BRAINERD PLANNING COMMISSION

RE: CUP – Lincoln Education Level IV Special Education Facility

Scott Whittemore has submitted a request on behalf of Independent School District #181 for a Conditional Use Permit for the Lincoln Education Level IV Special Education Facility at 400 Quince St., Brainerd, MN 56401.

CUP SUBMITTAL - 11/04/20

Sheet Number:
L1.01

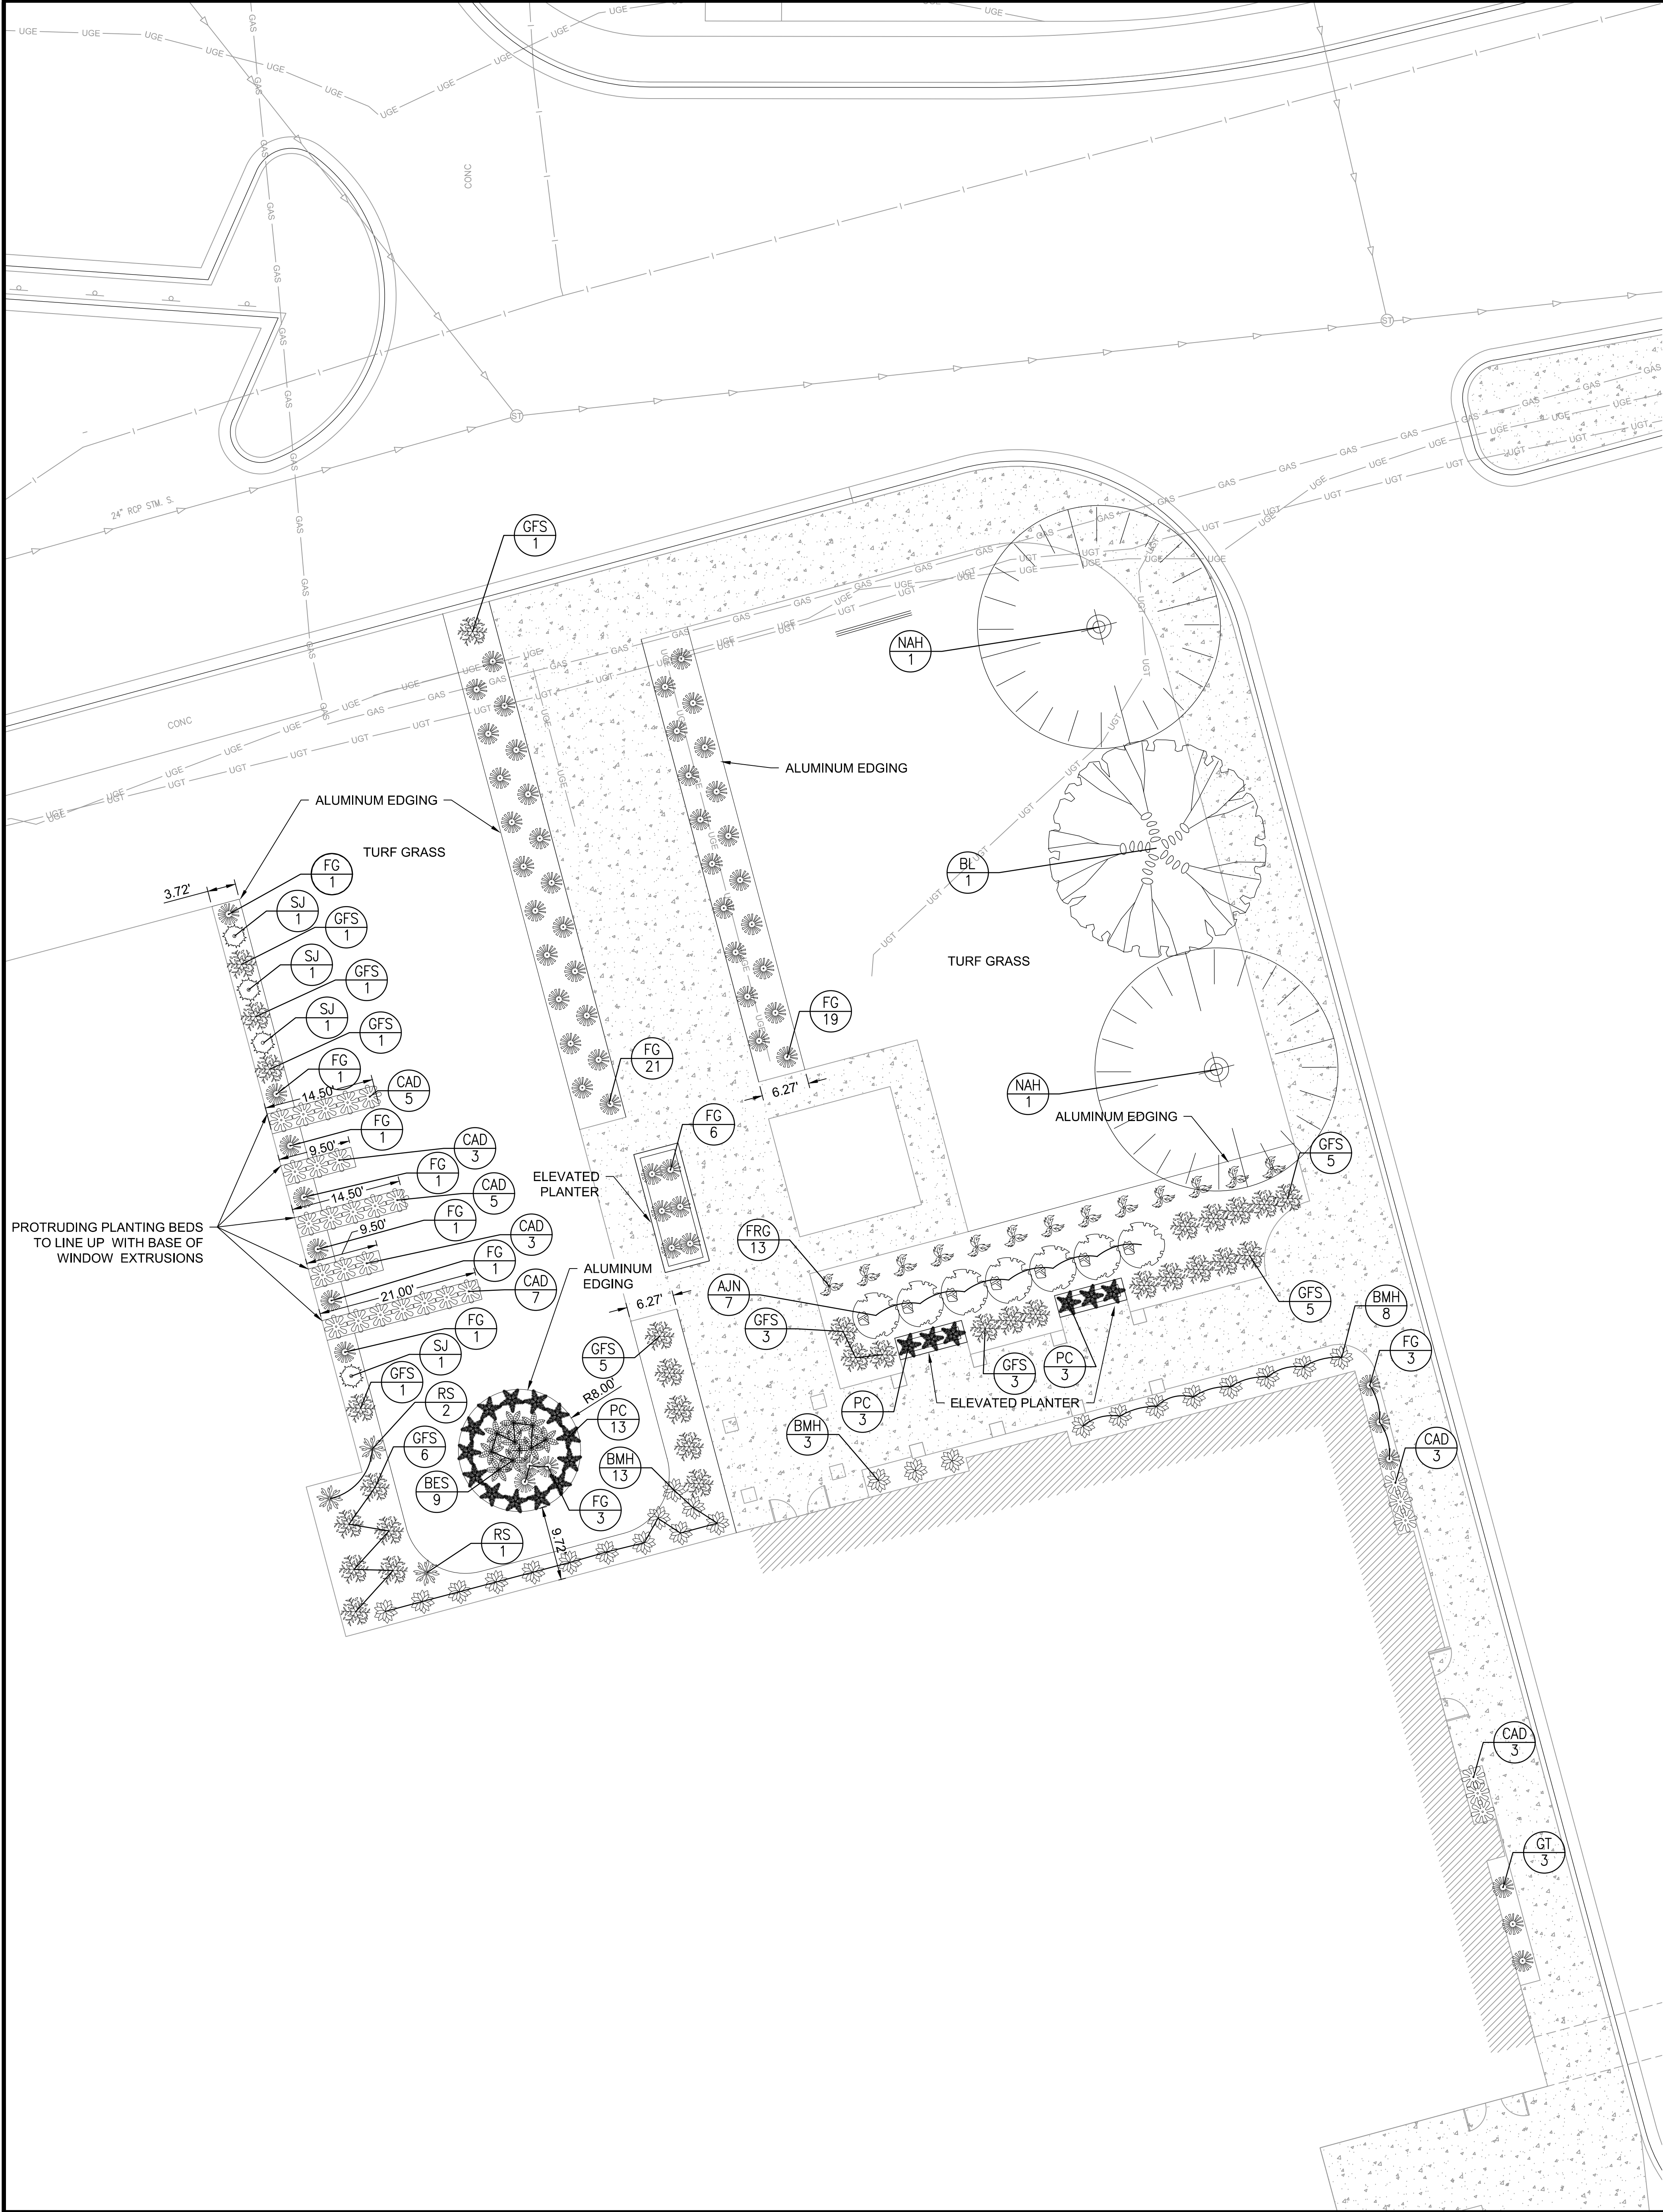
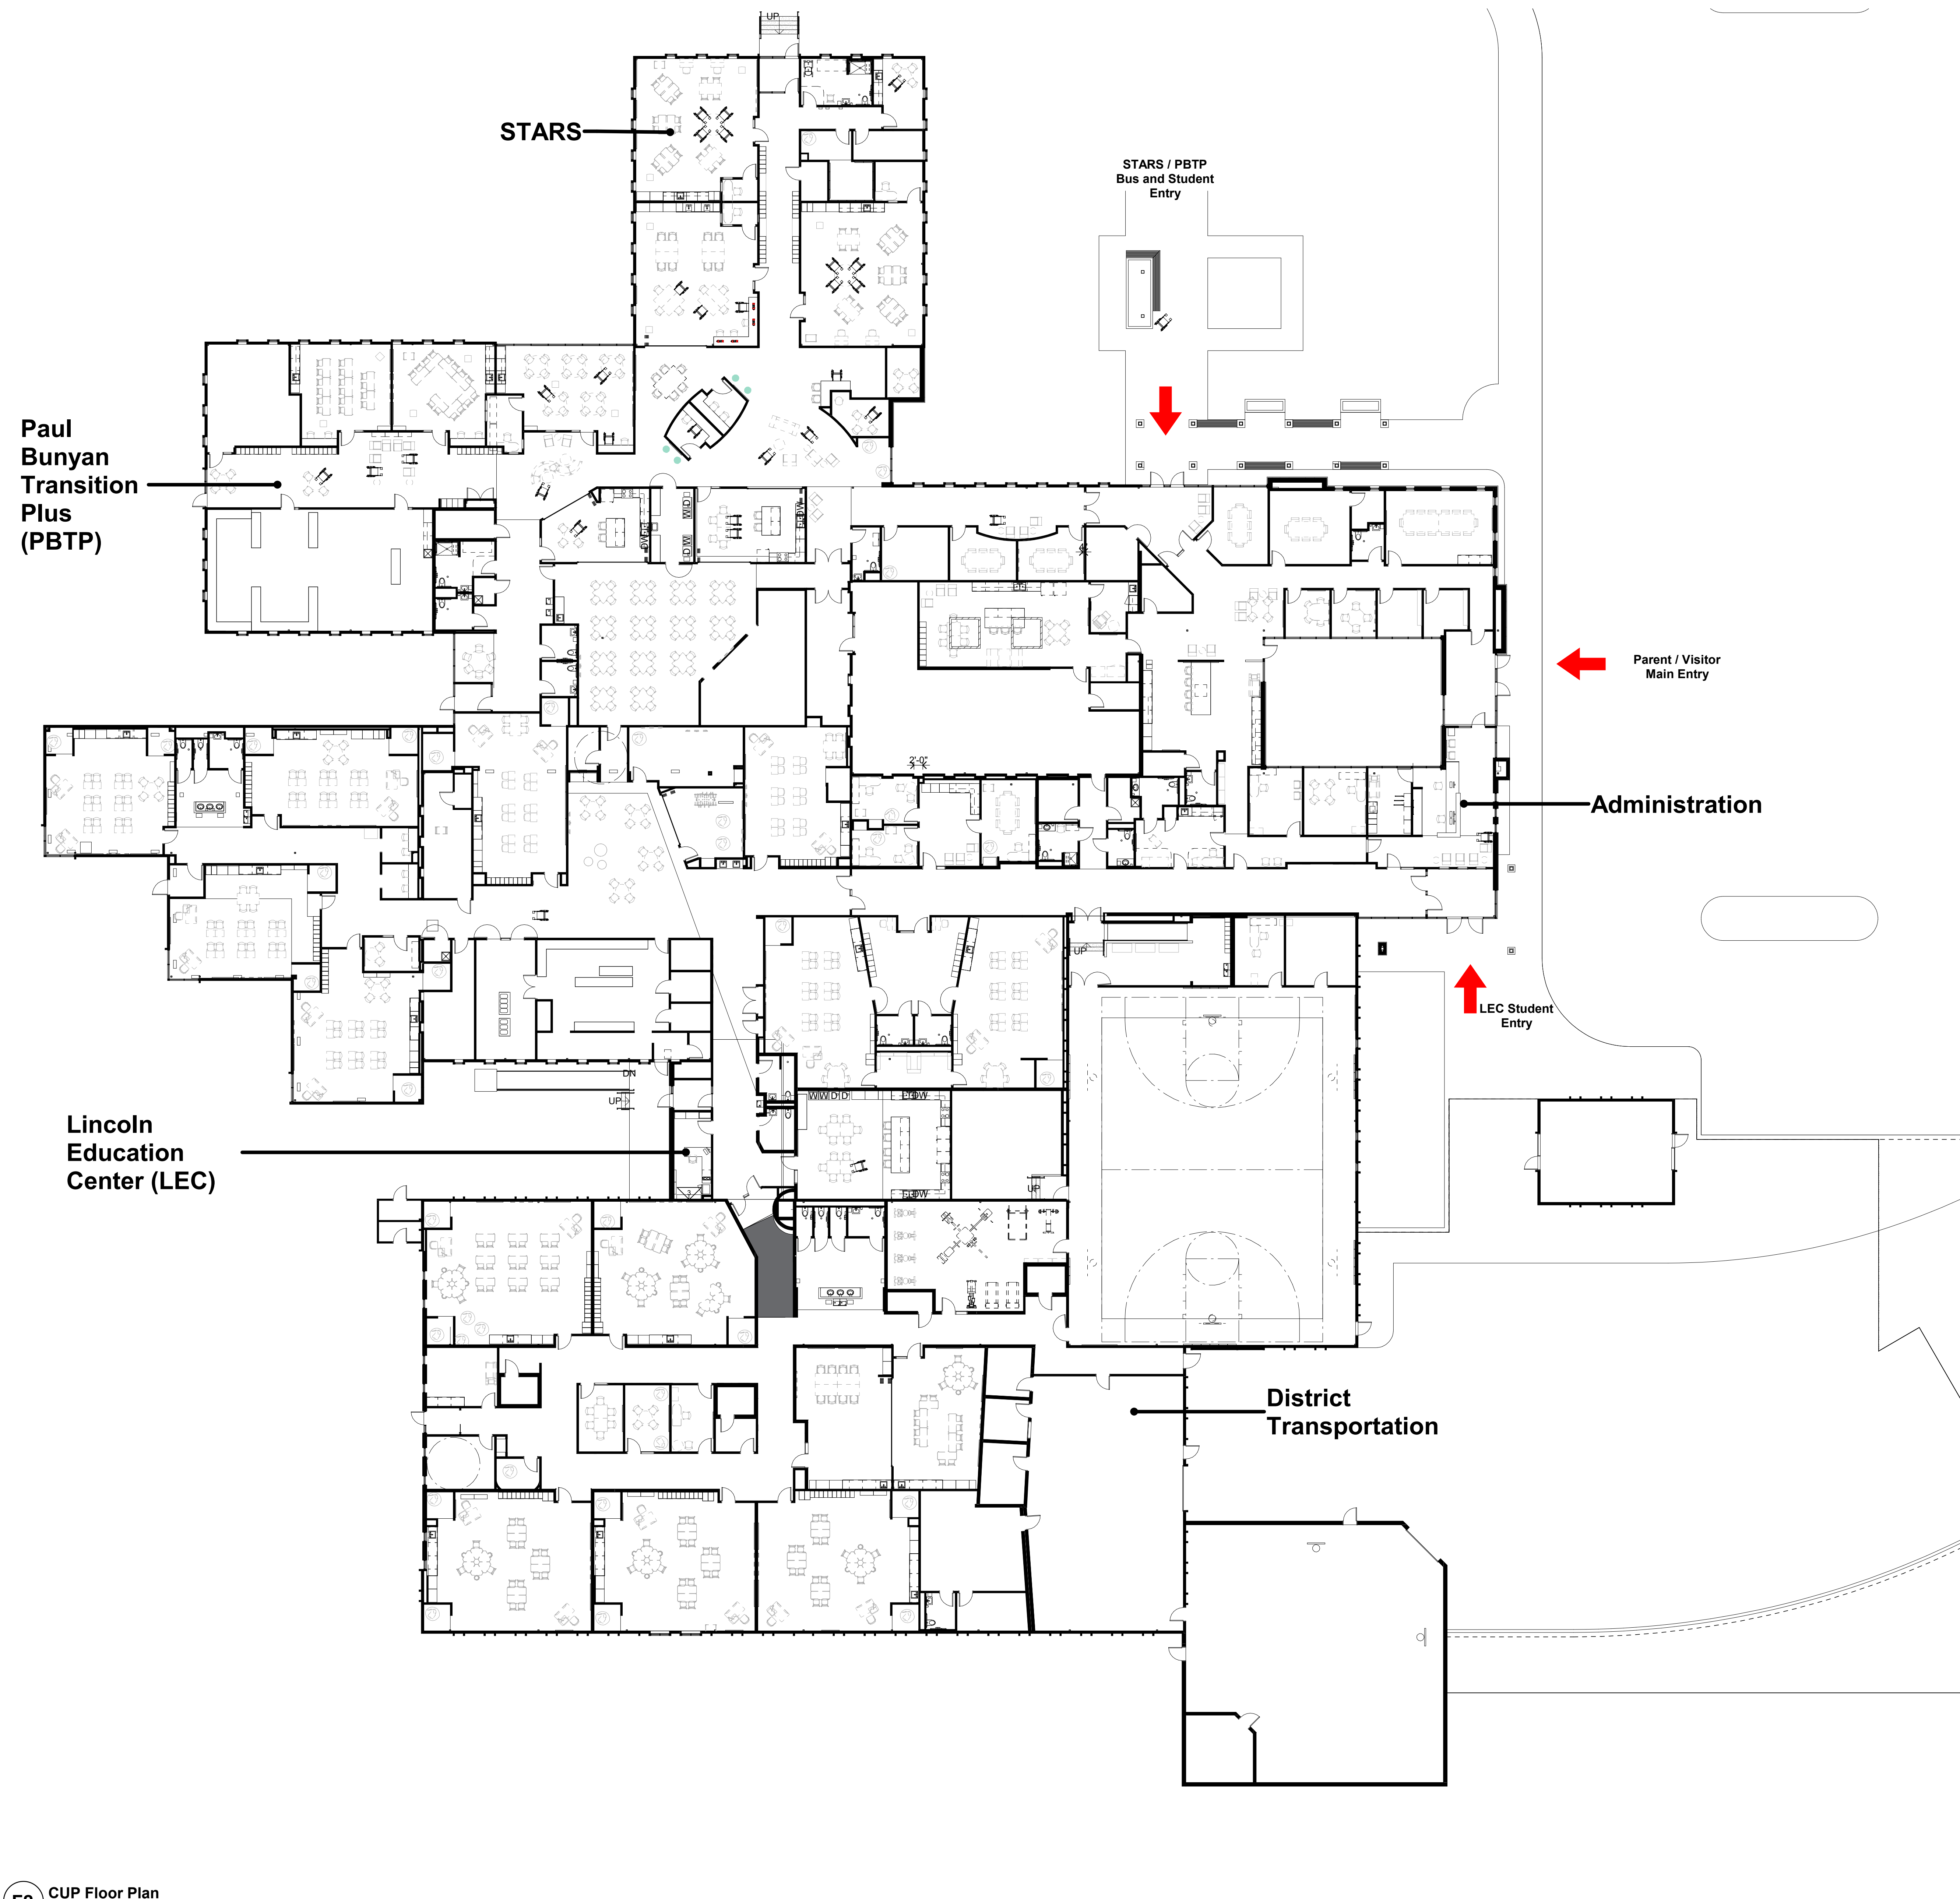
- i. The applicant has submitted a landscaping plan.
 1. Plan can be found on page L1.01 of their submitted documents.
 - c. Off-street parking is provided in accordance with [Section 22](#) of this Ordinance.
